## **Response to Representations – Application ID 23012013 42-46 Unley Road, Unley**

URPS continues to act for Otello Projects (the applicant).

**Figure 2 – Overlooking Analysis**

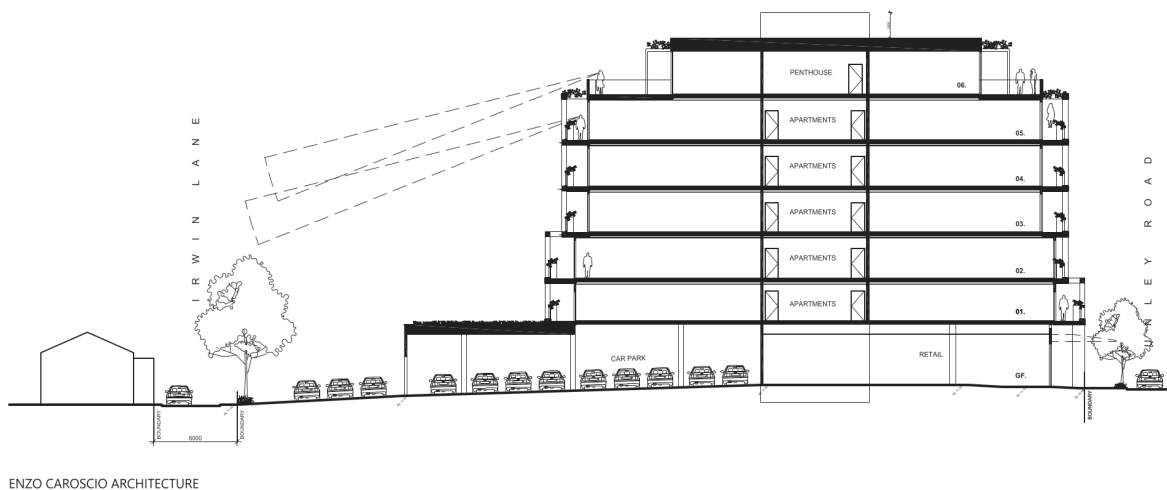
A number of representors of raised concerns regarding overlooking and overshadowing.

The rear-facing (western) apartments do not include screening along their western extent. Design in Urban Areas PO 10.1 and PO 10.2 provide the following policy guidance for overlooking and visual privacy:

In consideration of the above definition, the proposal eliminates direct overlooking to the western residential allotments and satisfies PO 10.1 and 10.2 because:

- Proposed windows and the east-facing balcony are located greater than 15 metres from the private open space and habitable room windows of residential properties on Salisbury Street.
- The upper-level setbacks further reduce the potential for direct sightlines into private spaces of nearby dwellings.
- 1.1m-high planter boxes are integrated along balcony edges to provide a natural privacy buffer, further mitigating potential overlooking into adjacent residential properties.

This is strengthened by the overlooking analysis provided by Enzo Caroscio Architecture which shows the viewing span distances in **Figure 2** below.

The dashed tapered sections in this figure represent a 15-metre distance from the viewer, and demonstrates that these do not extend past the rear (western) boundary of the subject land.
